**Eugene School District 4J
ROOSEVELT MIDDLE SCHOOL**
680 East 24th Avenue
Eugene, OR 97405
CIP No. 410.566.001

ADDENDUM NO. 1

This Addendum forms a part of the Contract Documents and modifies the original Bidding Documents dated February 18, 2015 as noted below. Acknowledge receipt of this Addendum in the space provided on the Bid Form. Failure to do so may subject the Bidder to disqualification.

A1 FIRST FLOOR PLAN - ZONE A
 1/8" = 1'-0"

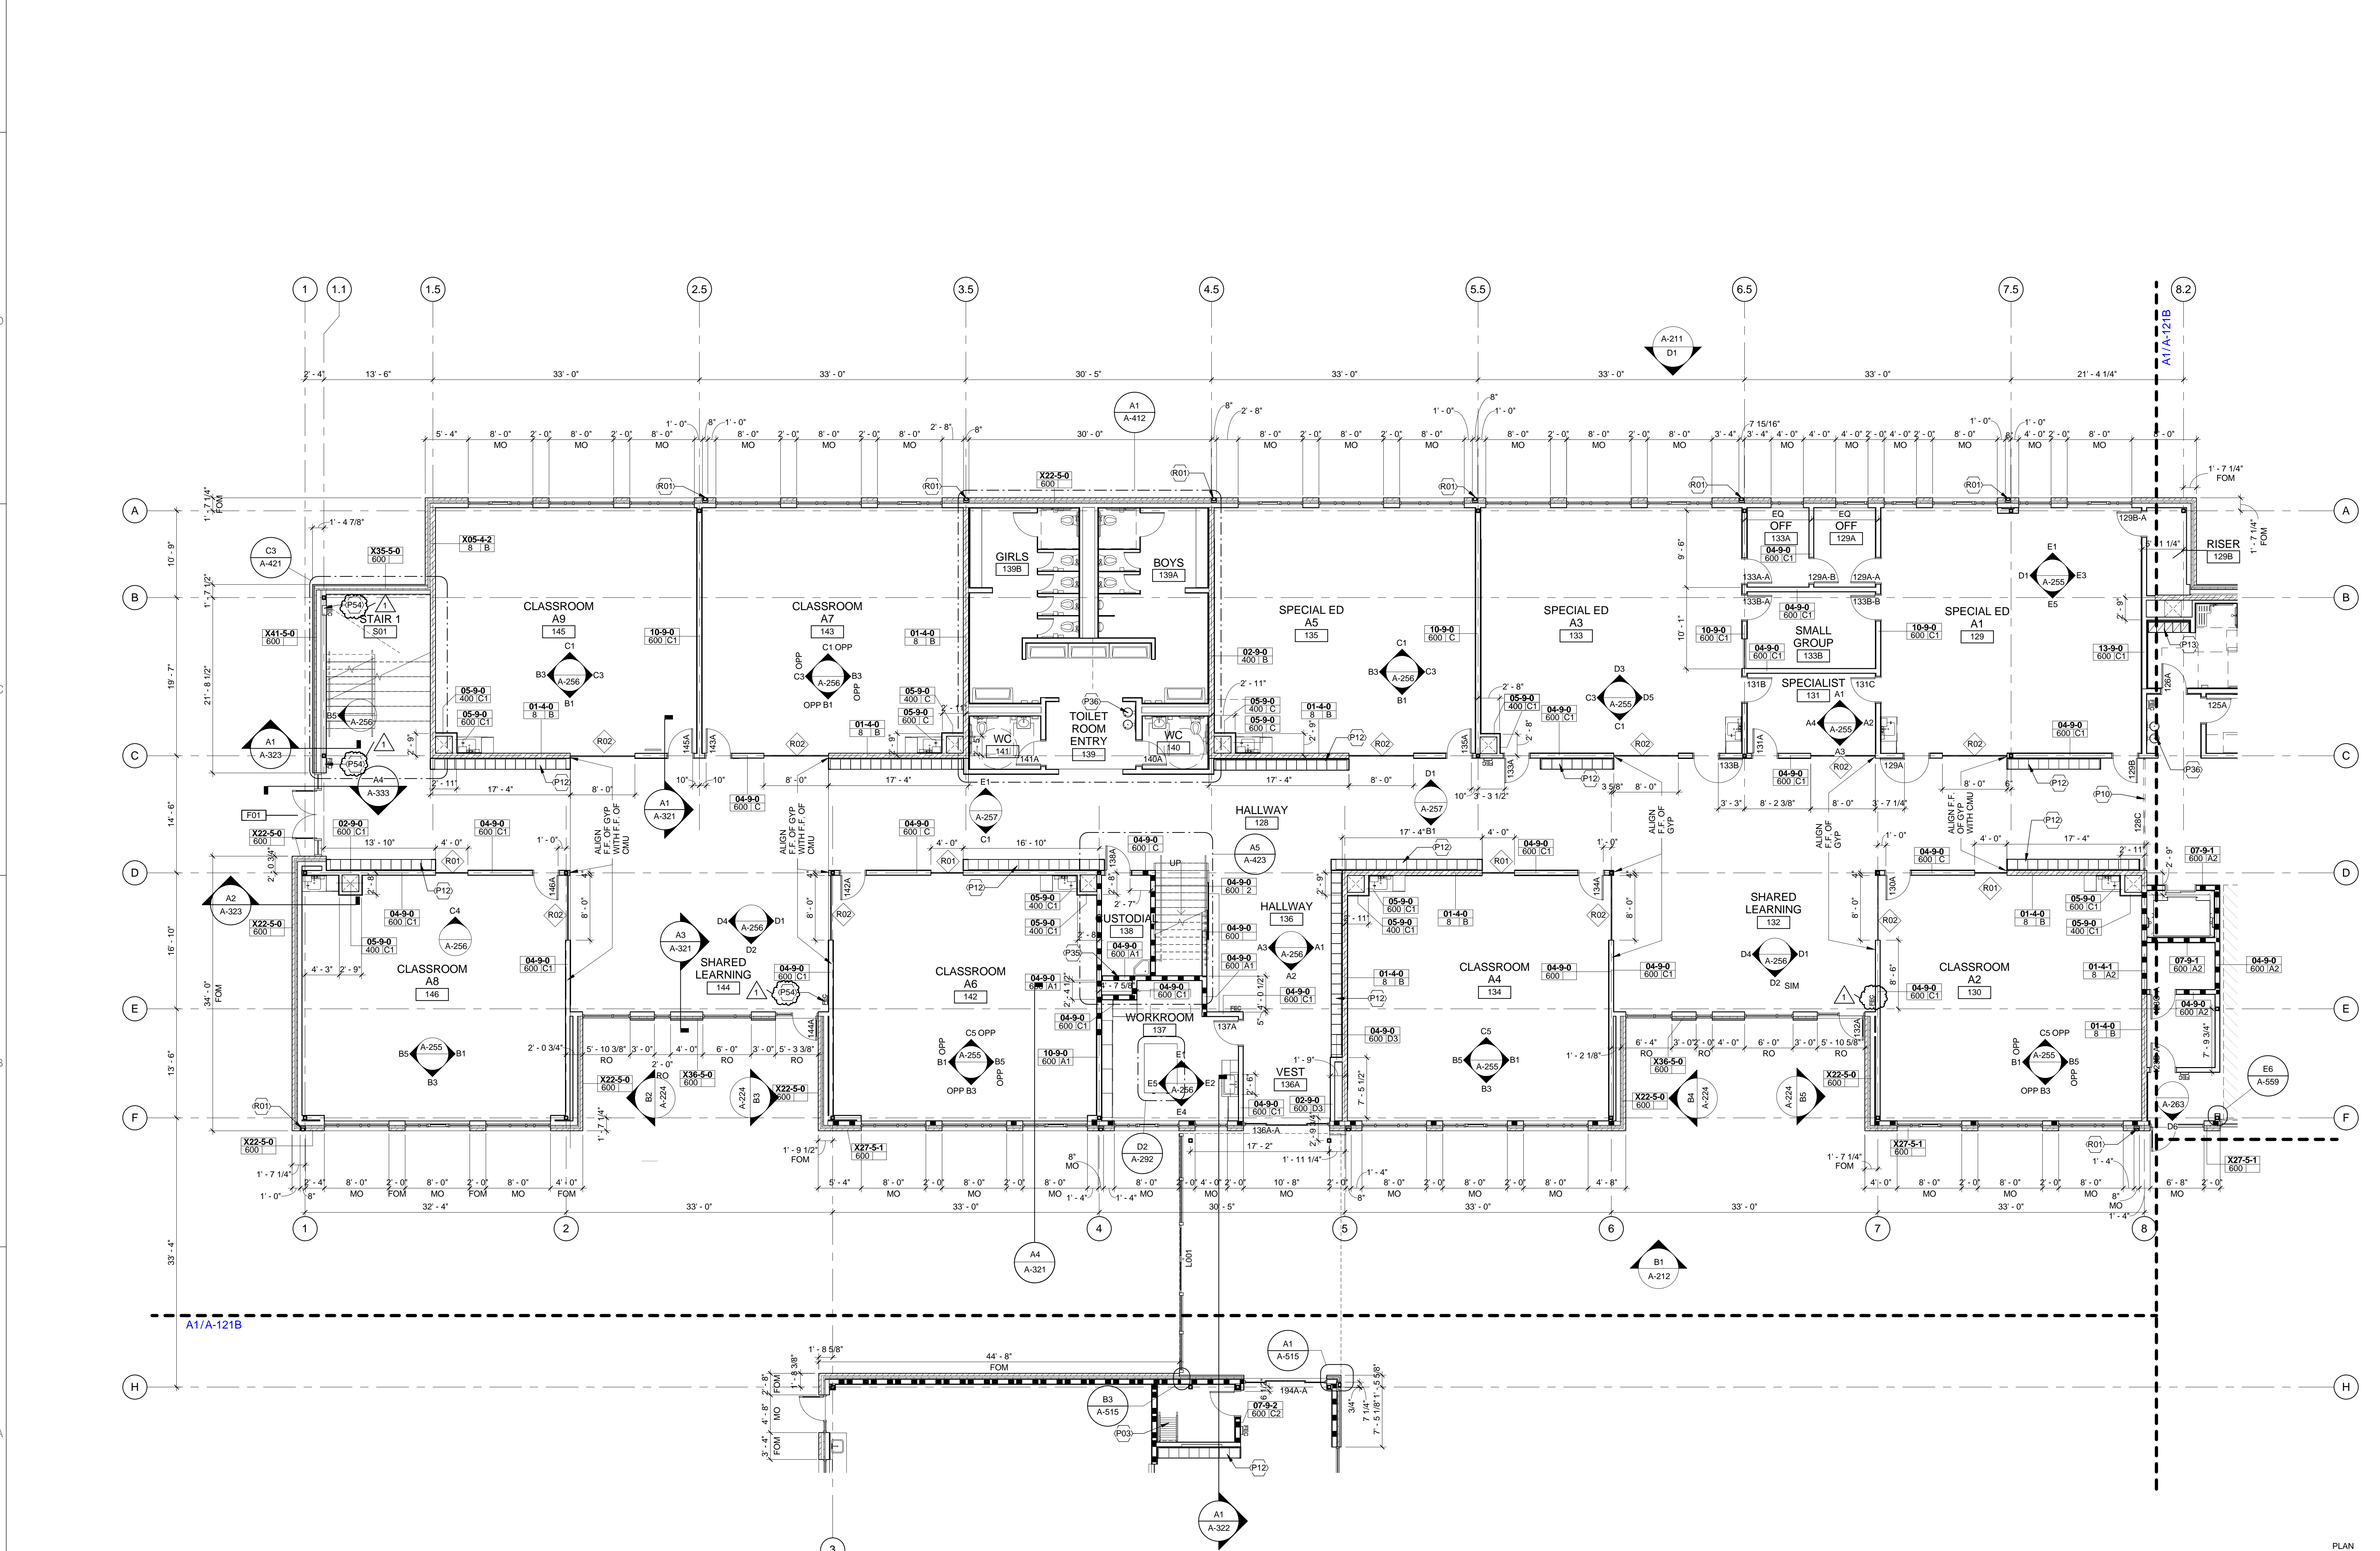
A. Replace Sheet with attached new Sheet A-121A. Clarification: Added tags for fire-extinguishers.

SECOND FLOOR PLAN - ZONE A

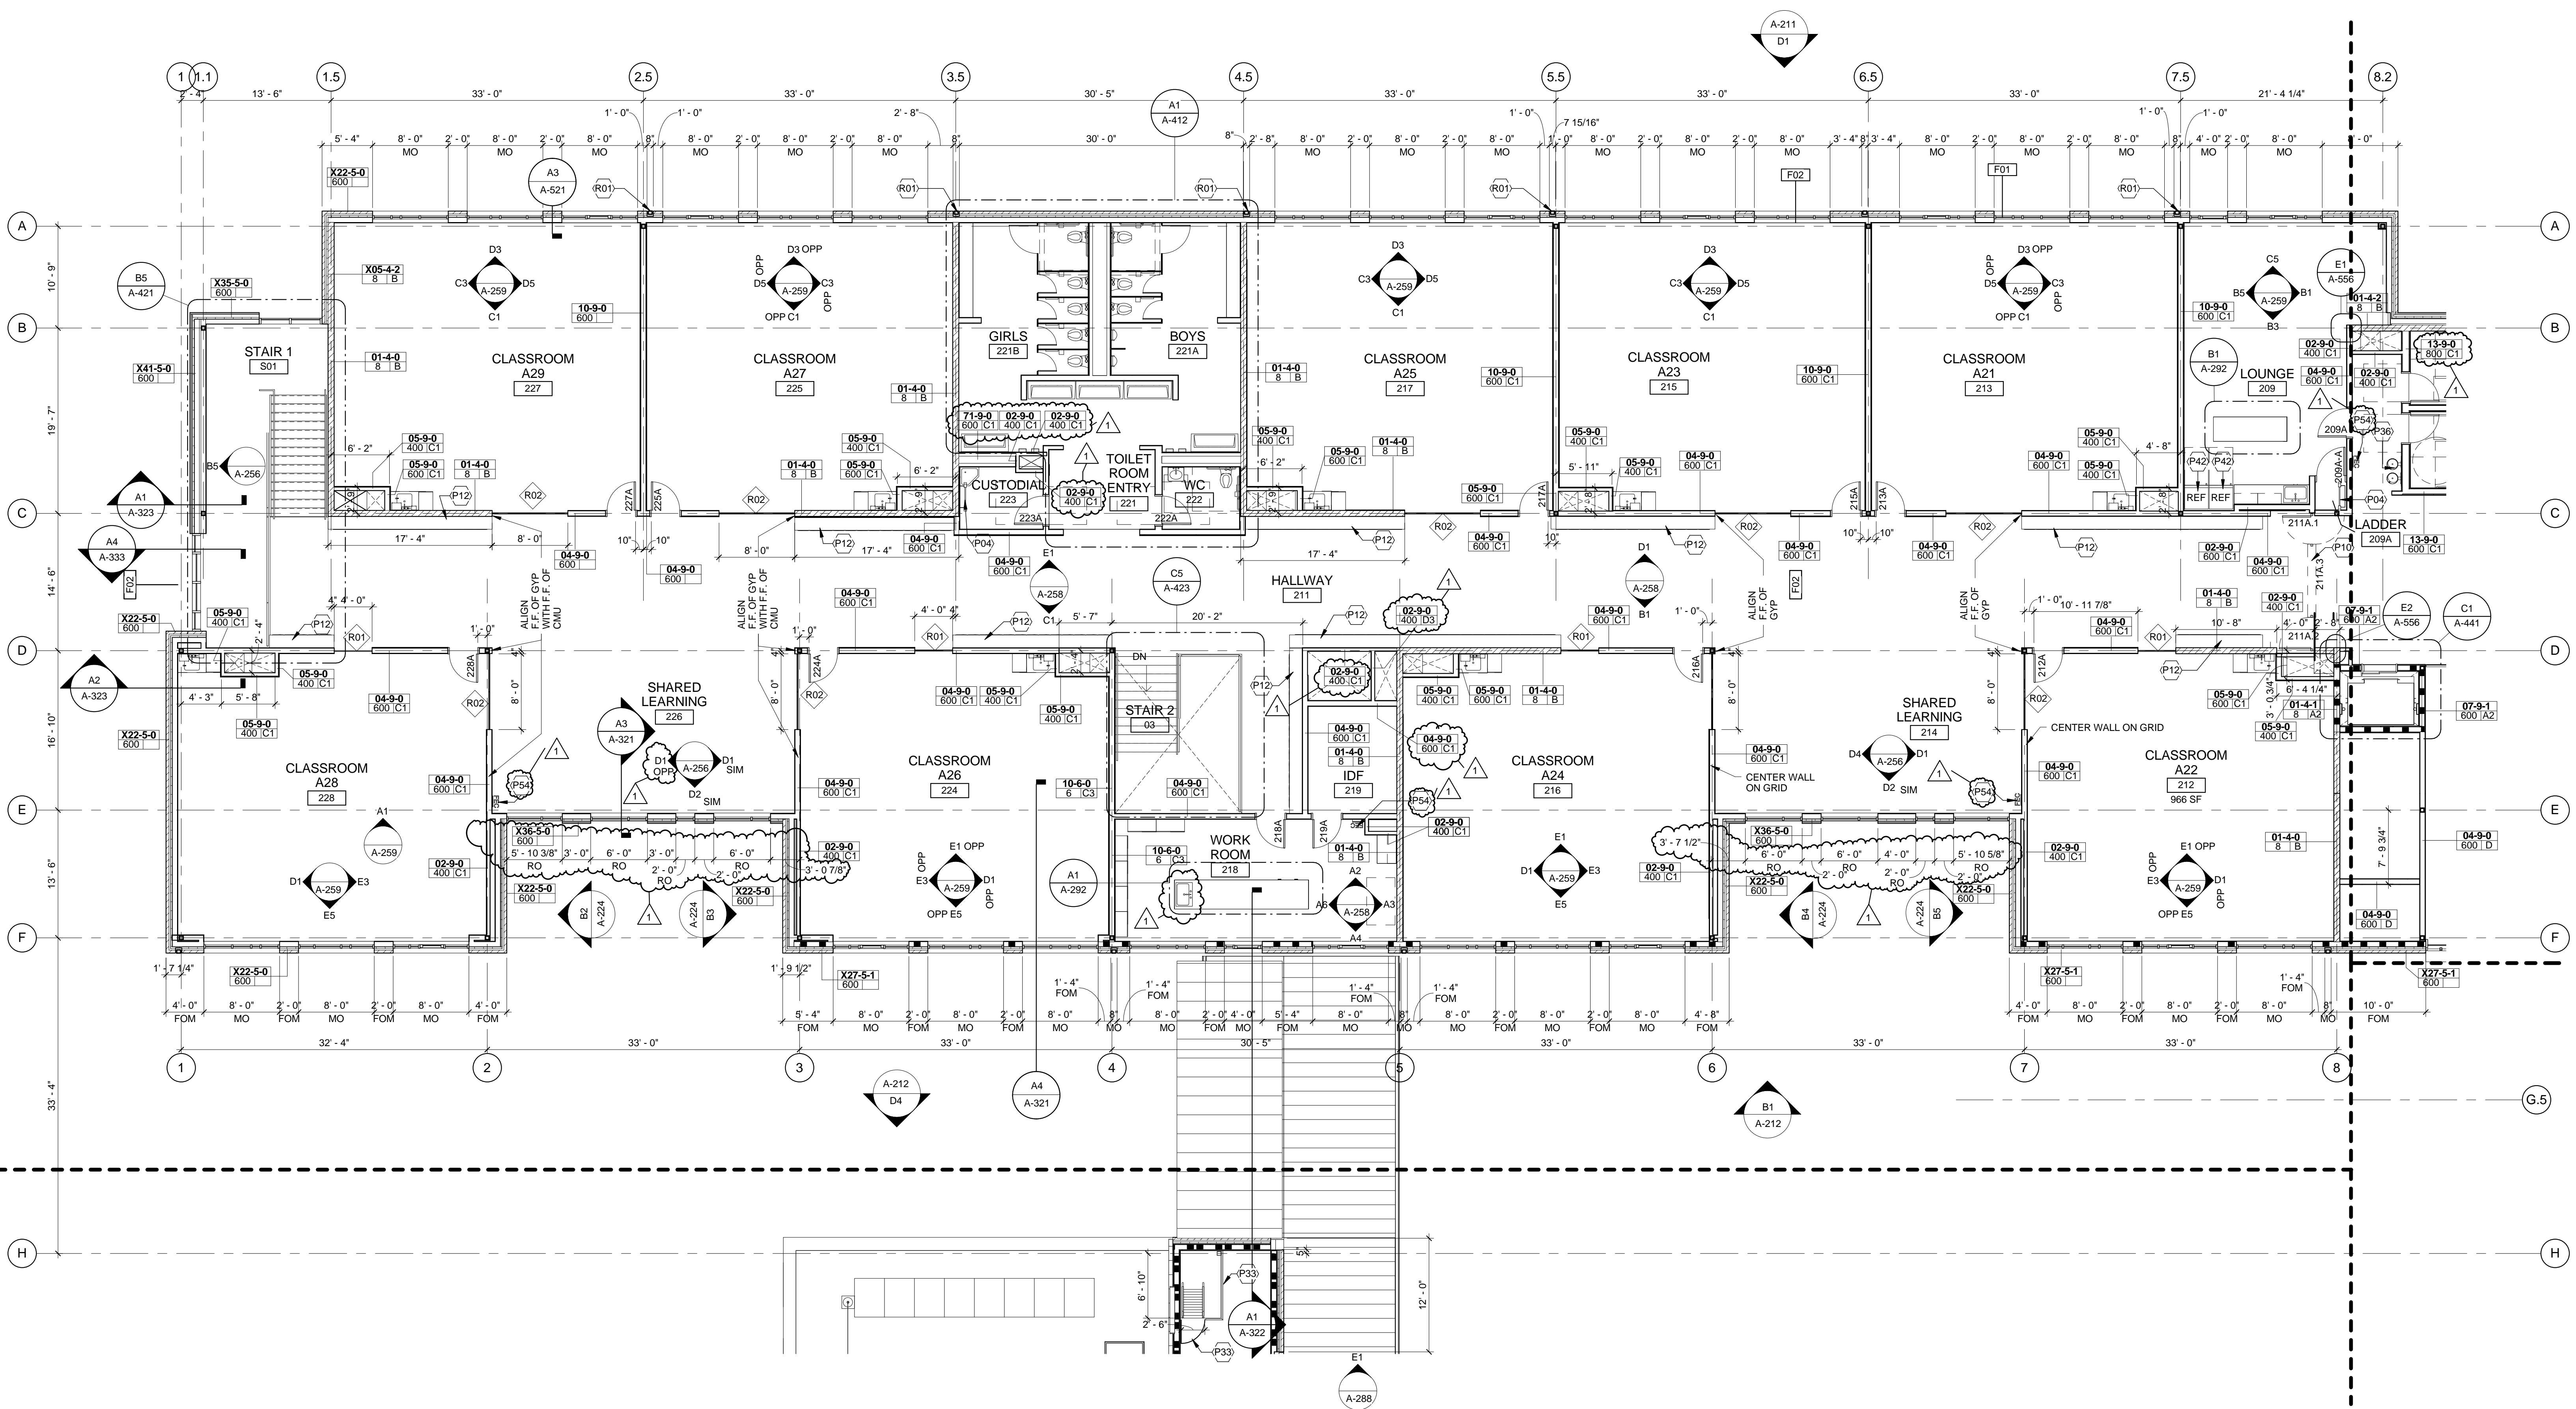
A. Replace Sheet with attached new Sheet A-122A. Clarification: Added wall tags, added sink in Room 218 and updated dimensions.

MECHANICAL EQUIPMENT PLATFORM PLAN - ZONE A

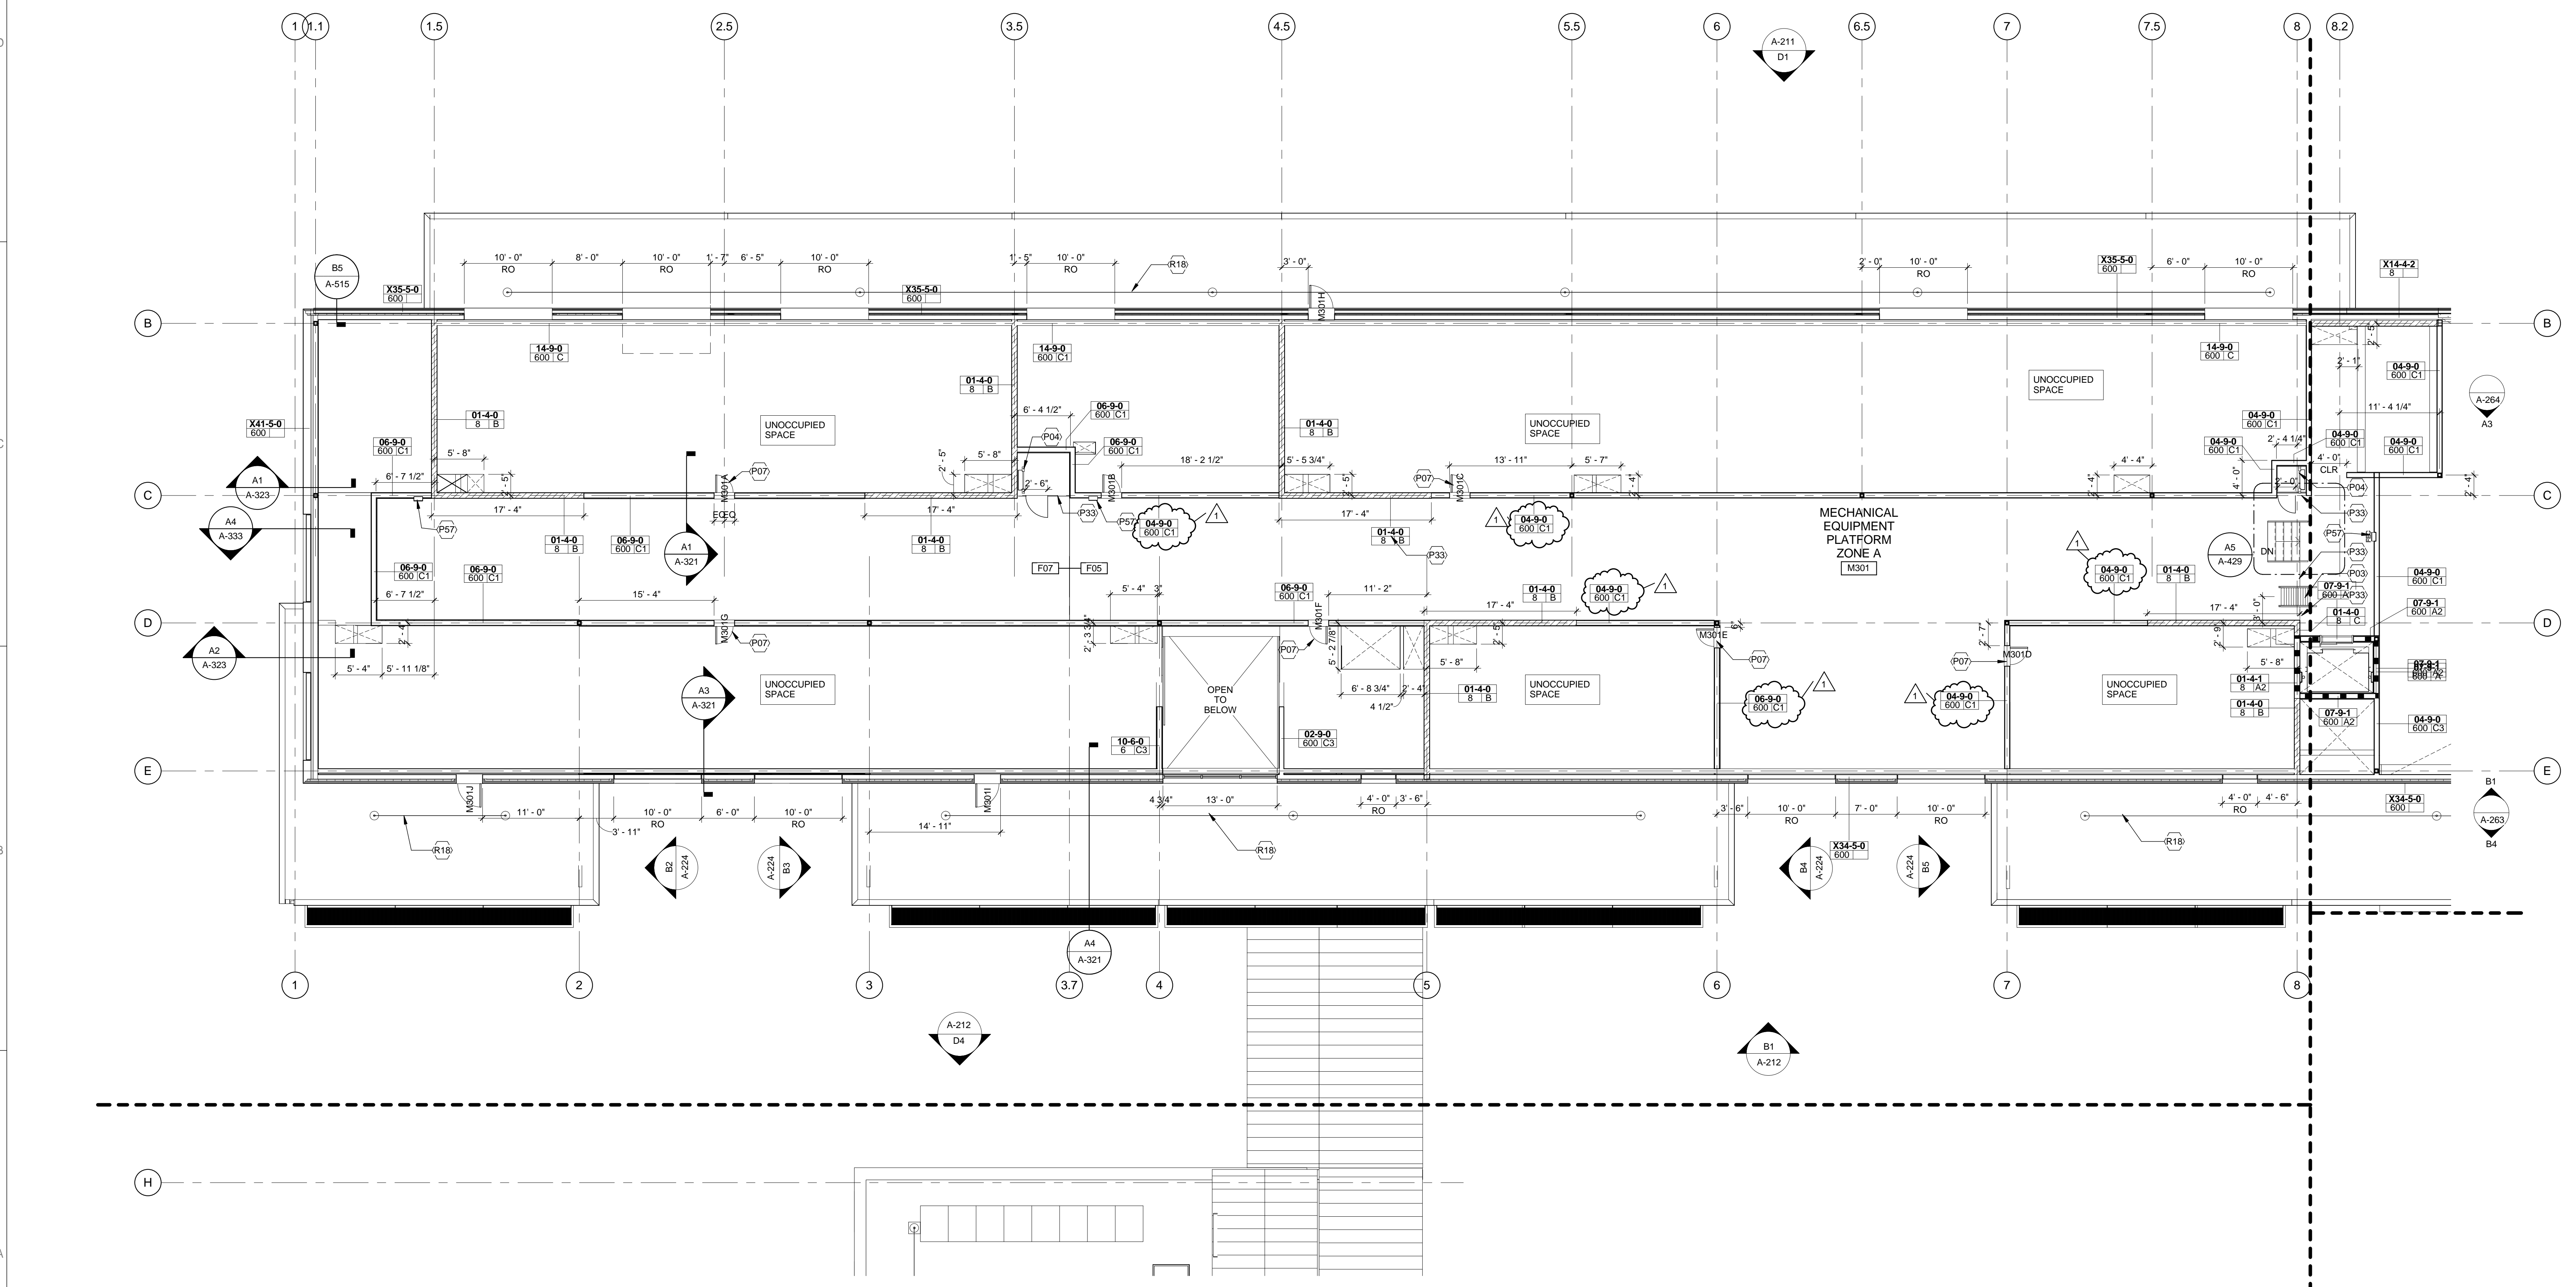
A. Replace Sheet with attached new Sheet A-131A. Clarification: Modification of floor types.
